VESSELIVE

APARTMENT BUILDINGS

9051&9055 20th Avenue SW, Seattle WA 98106

Second Early Design Guidance Meeting

OPTION 1

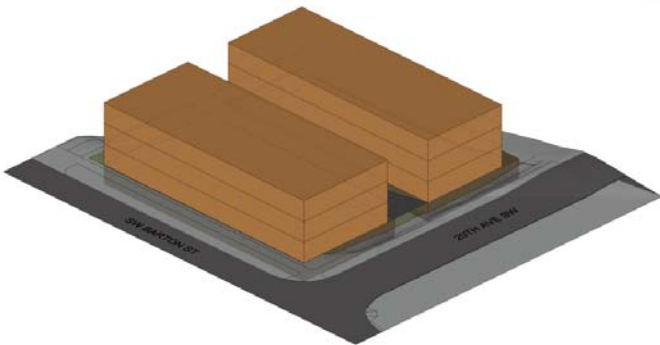
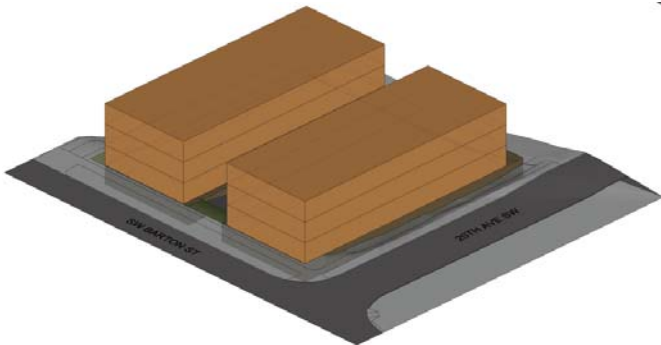
EDG FIRST MEETING COMMENTS AND RECOMMENDATIONS:

- Street level to comply with the requirements of the Land Use code for 13 feet floor-to floor height of commercial space.
- The intent of C40 Zone is to have taller buildings and to look into perspective.
- The driveway between the building is not visually appealing.
- The design language is interesting and engaging.

DESIGNER'S RESPONSE:

- The street level floor height was increase to 12'-10"
- With the proposed configuration the building has four floors of height along 20th Ave SW..
- The driveway was eliminated and the access to parkade level is via interior ramp.
- The design language was used in the development of the revised project.
